Subject: Grand Gulf Nuclear Station  
Docket No. 50-416  
License No. NPF-29  
Response to Generic Letter (GL) 95-07  
Request for Additional Information

GNRO-97/00056

**Response to NRC Request for Additional Information**  
**Generic Letter 95-07**

TEST DATA FOR 14-INCH WILLIAM POWELL GATE VALVE

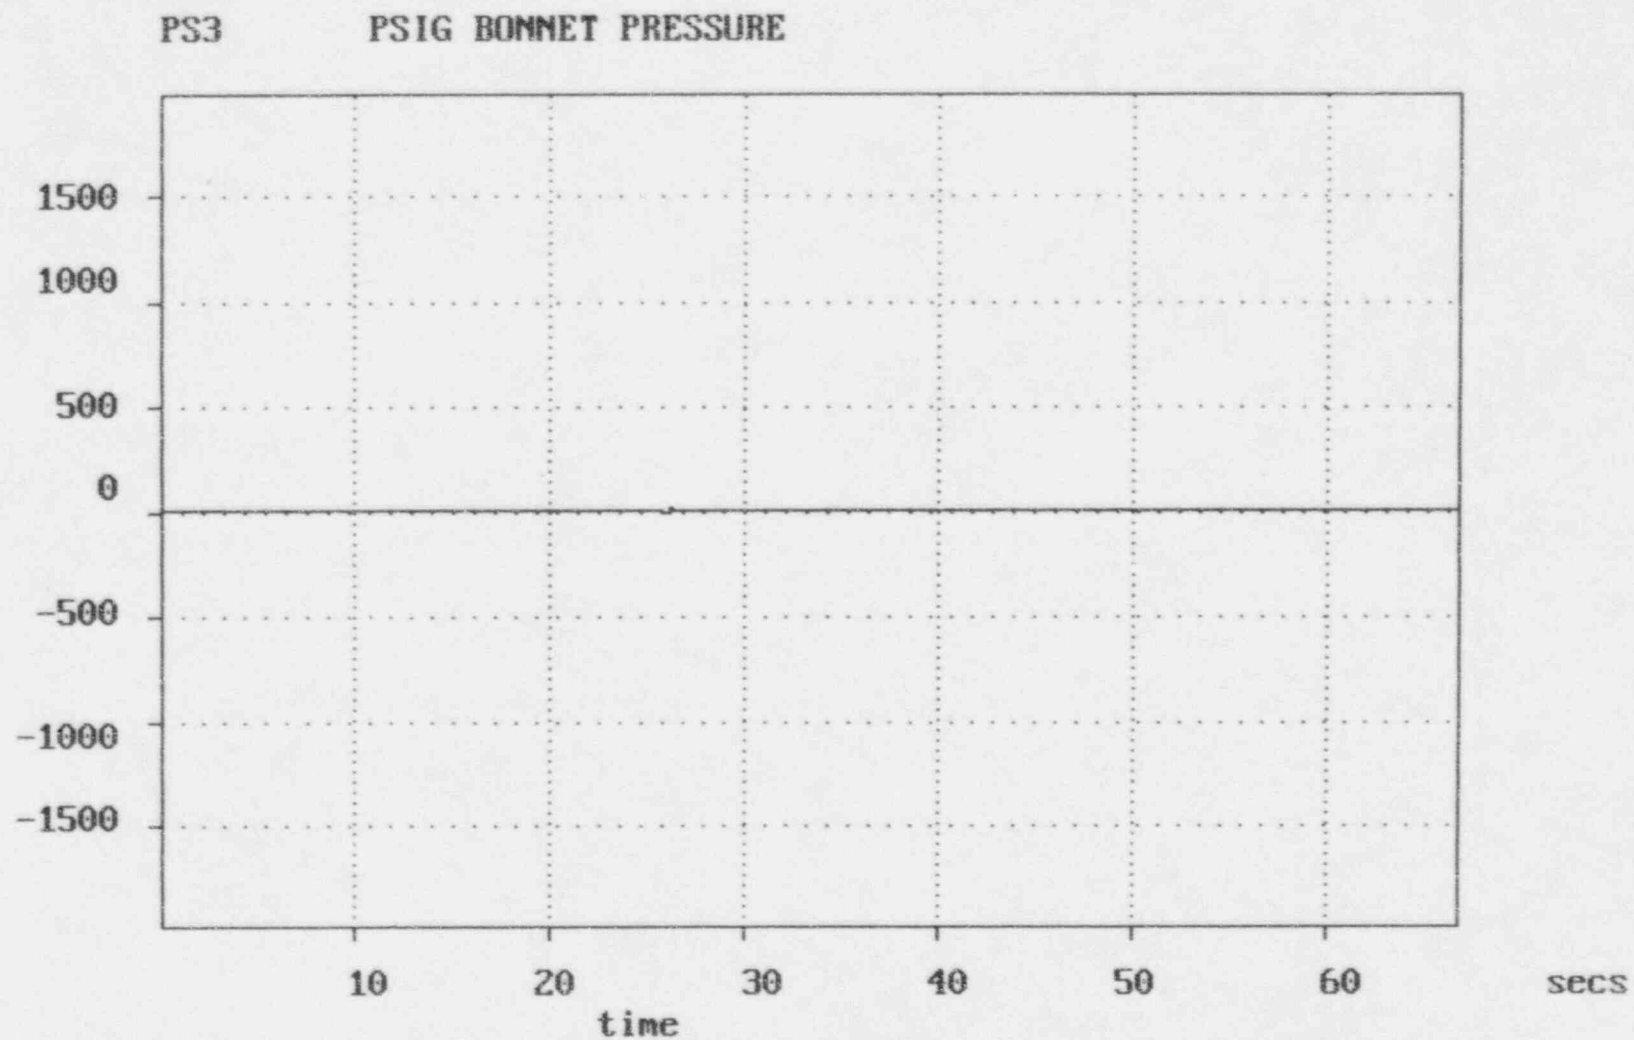
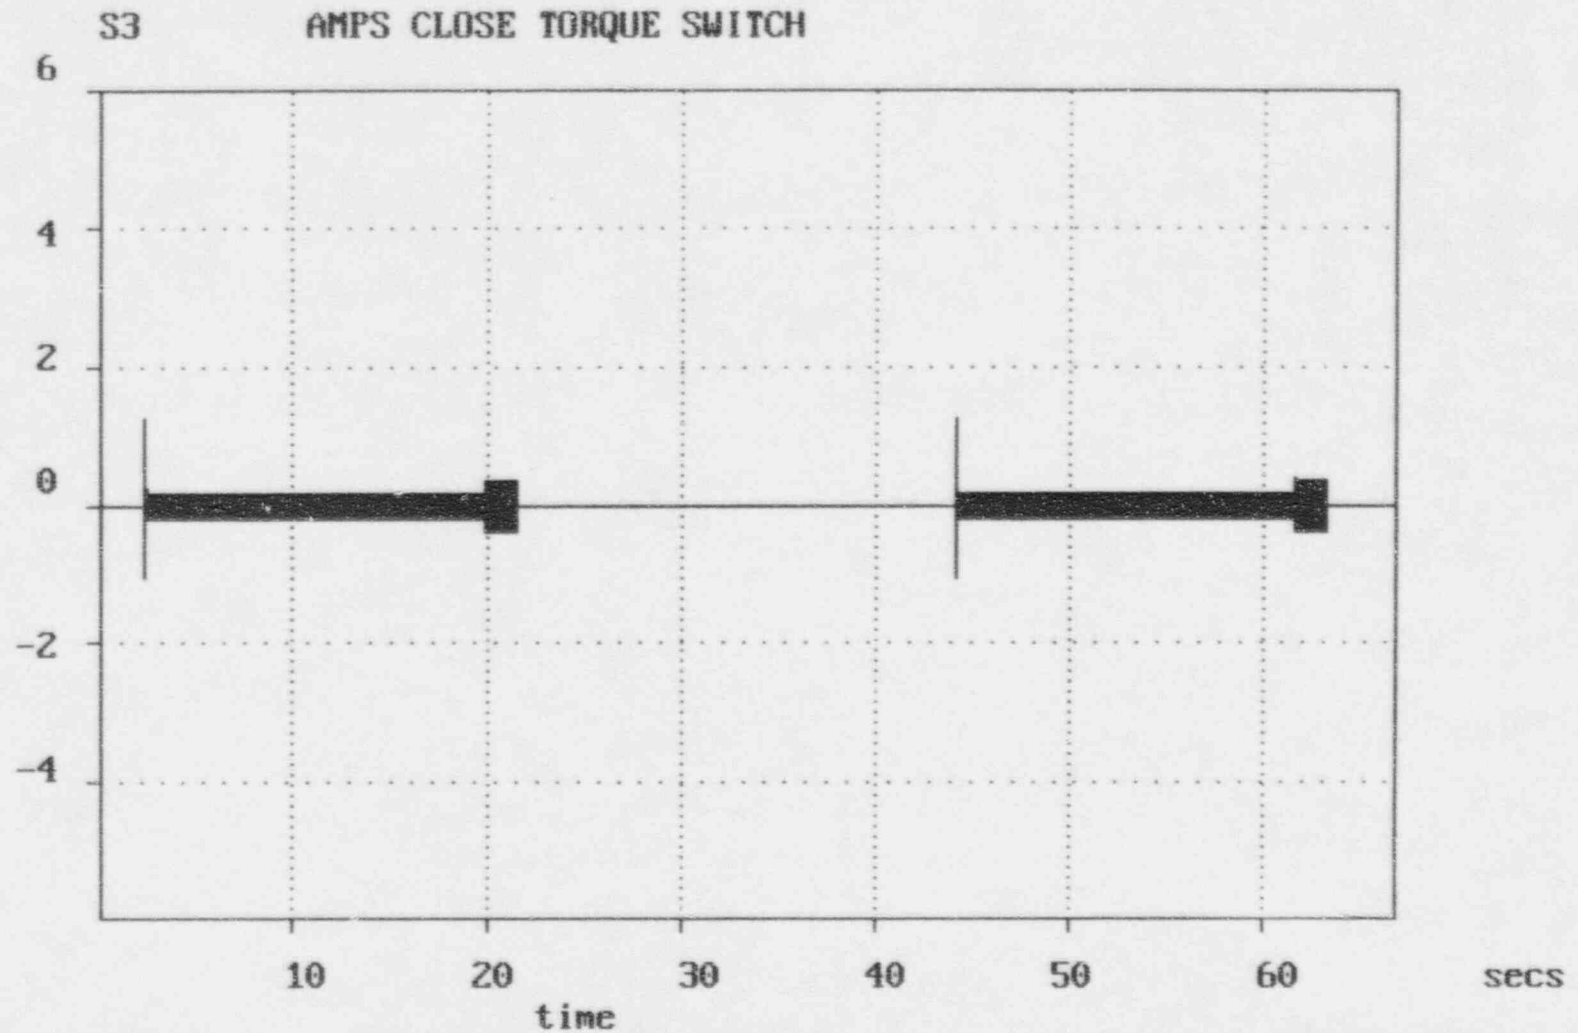
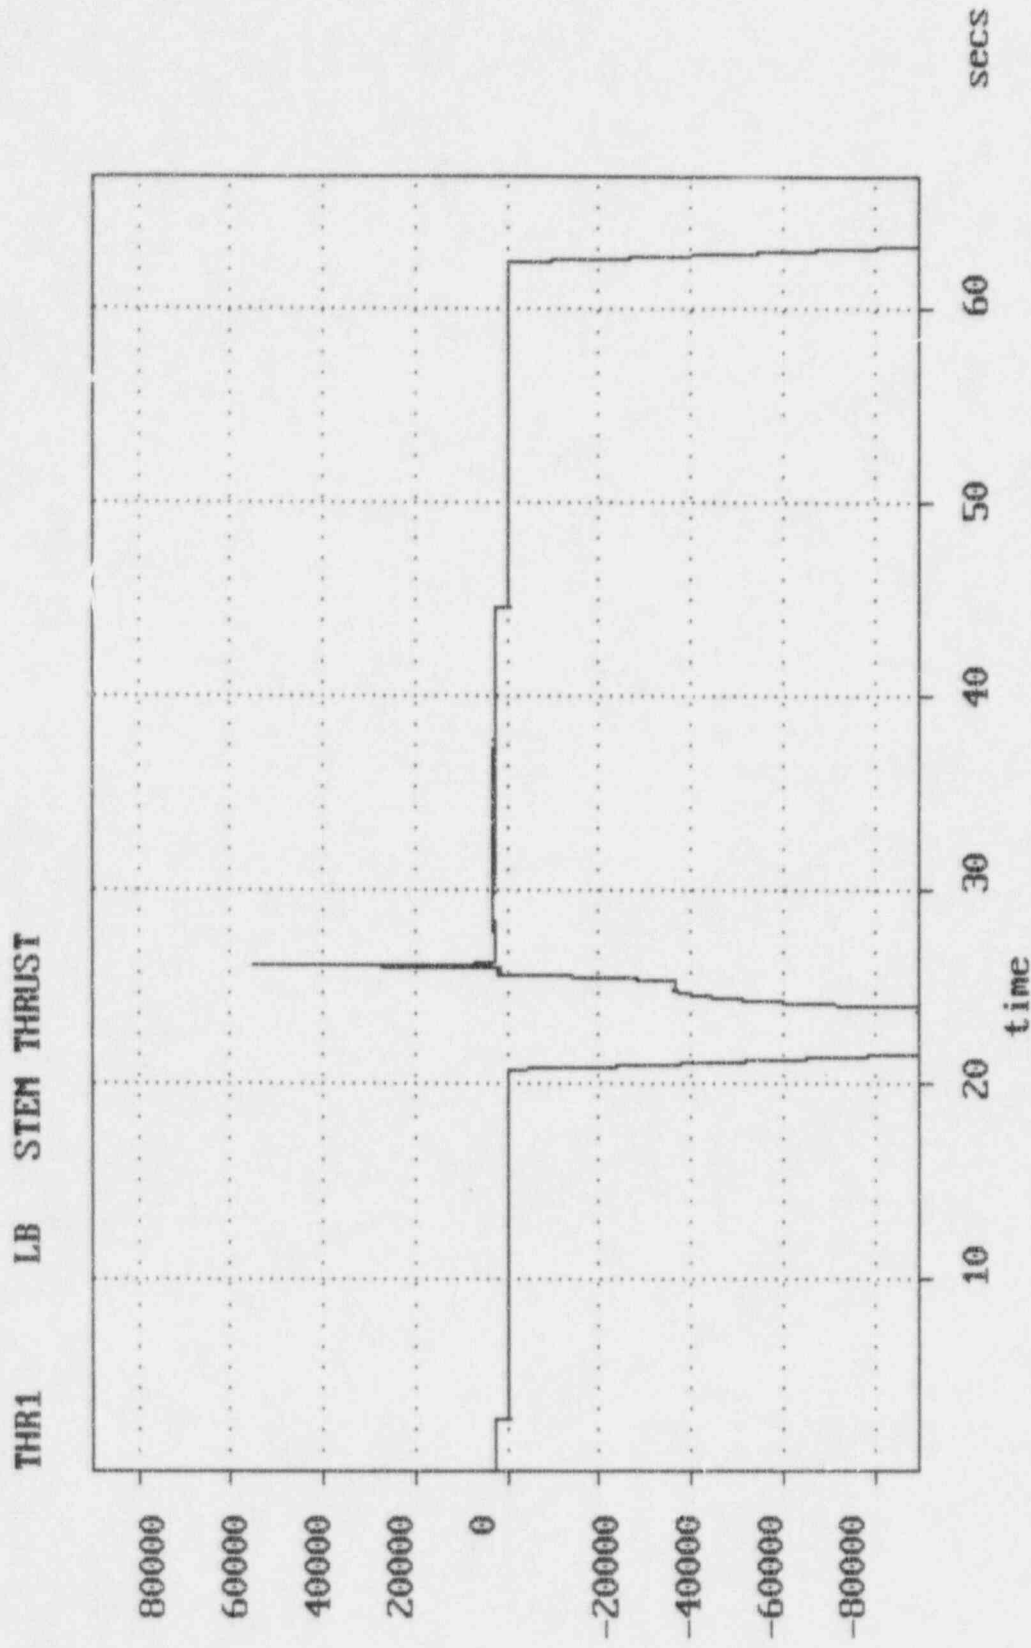
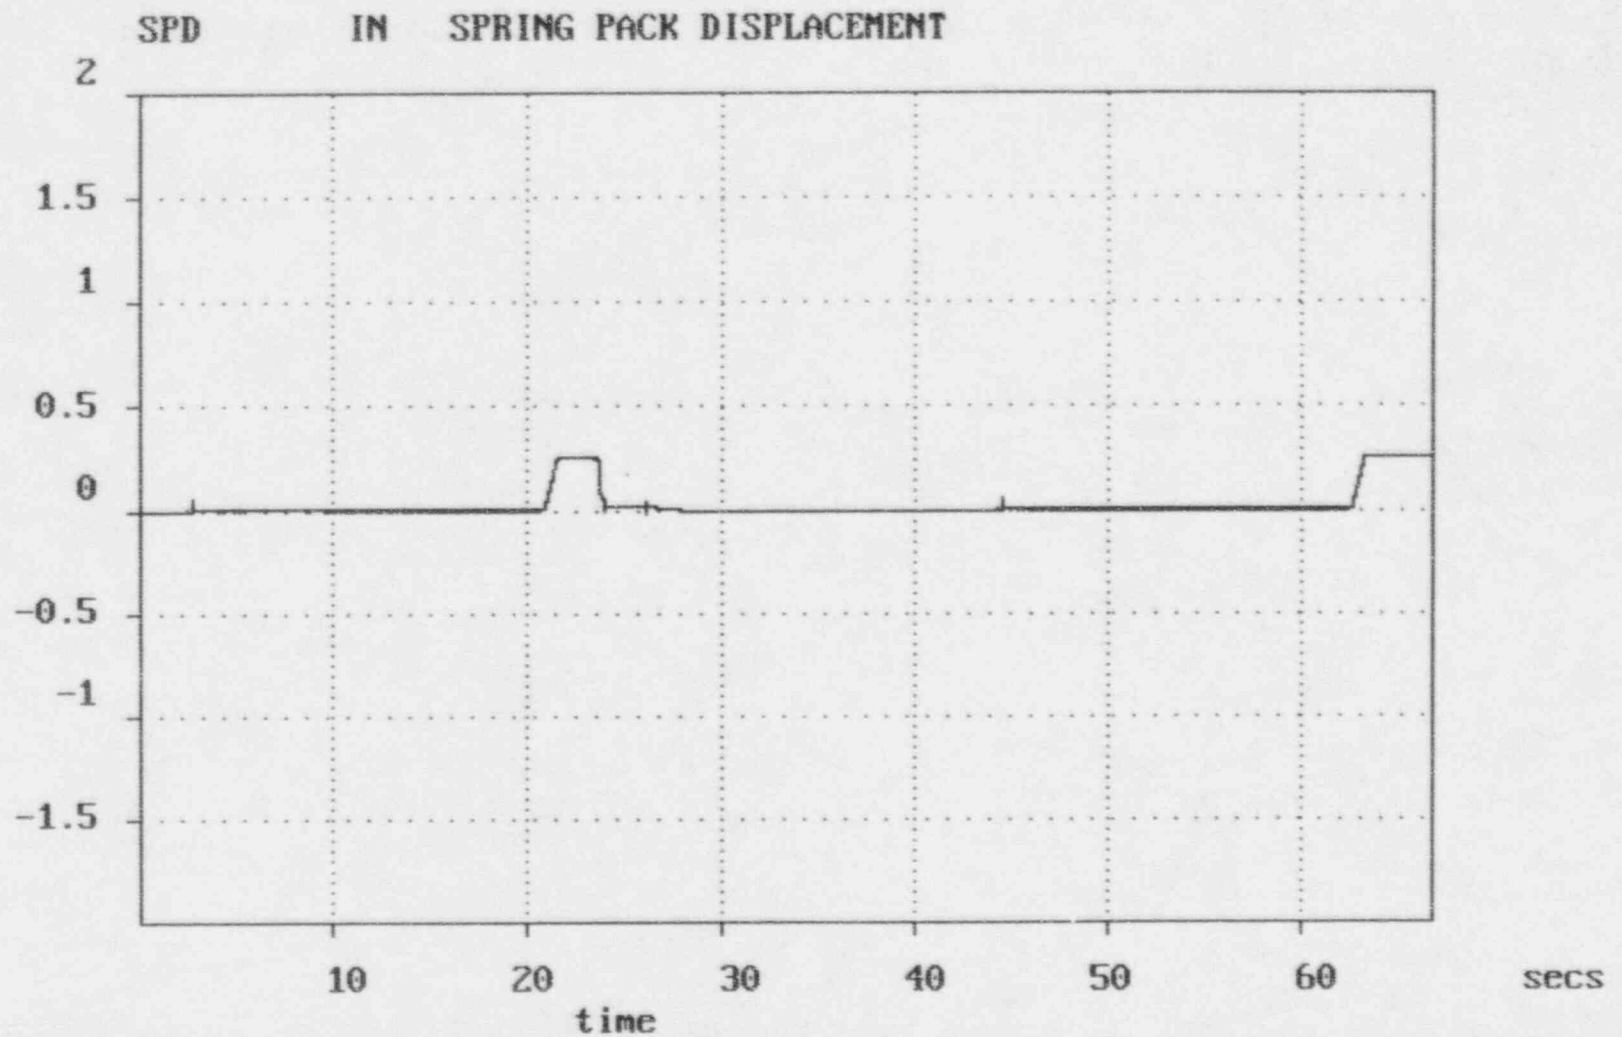
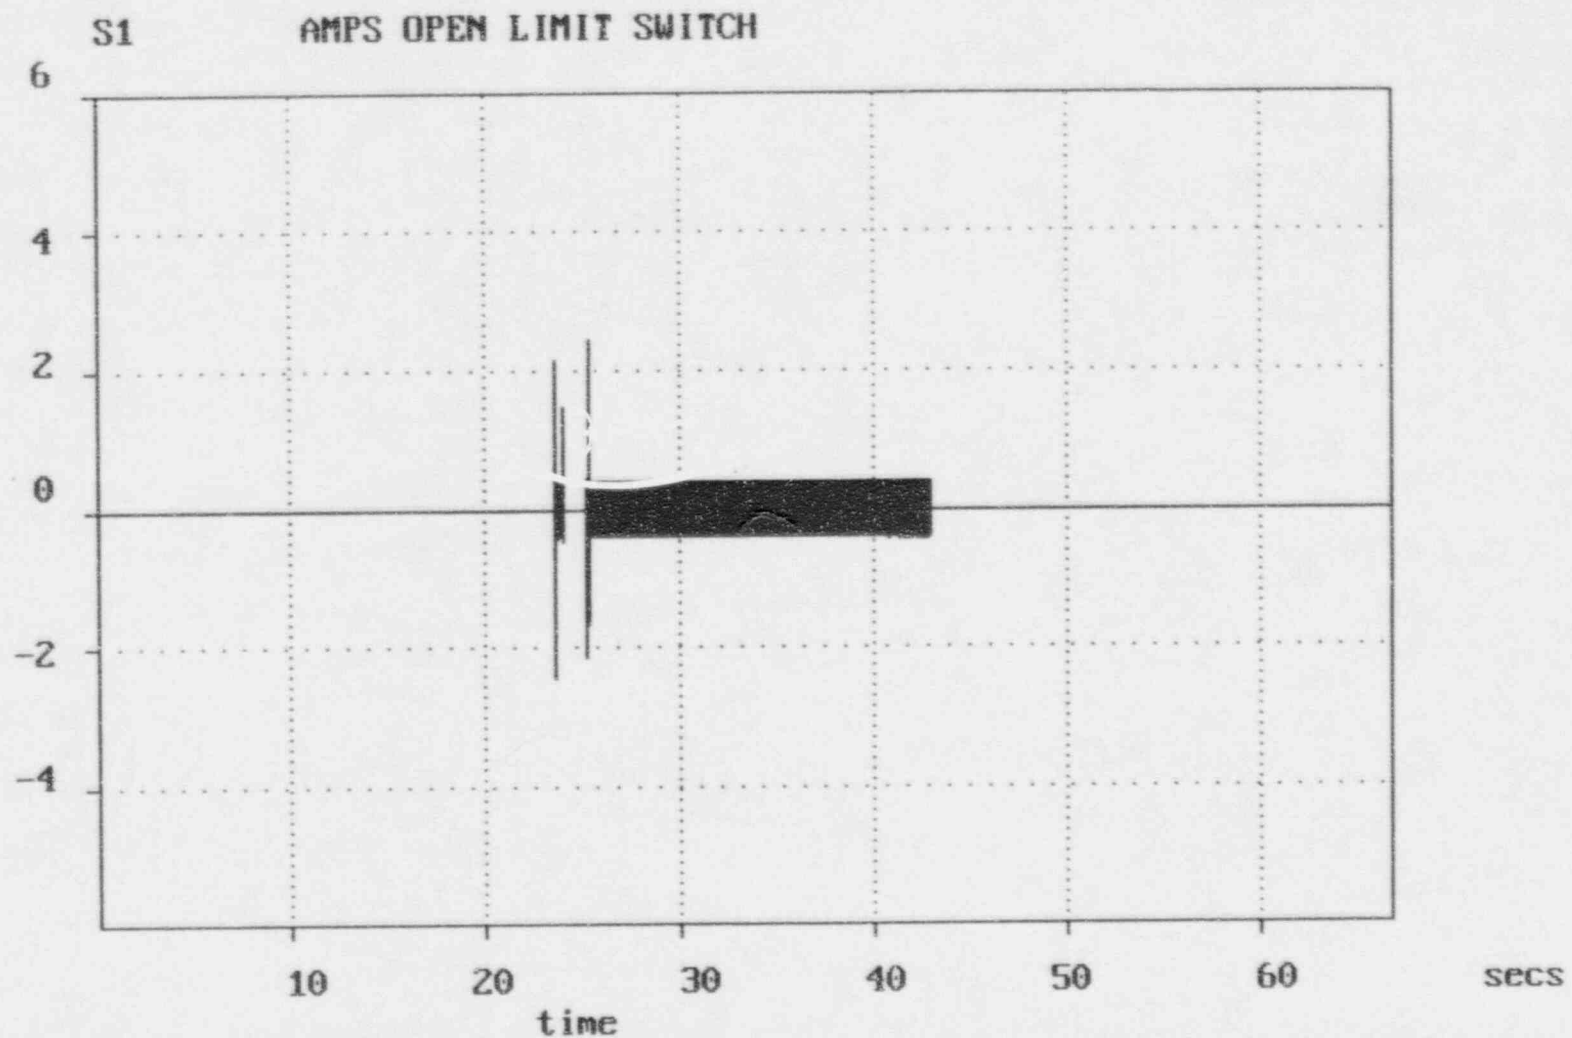
1. "The NRC staff reviewed the test report (14-inch William Powell Gate Valve) but the information necessary to independently verify the pressure locking test results was not in the report. Discuss the schedule when the test data can be provided to the staff."

The test data on the 14 inch William Powell gate valve is provided as Appendix 1 to this package.
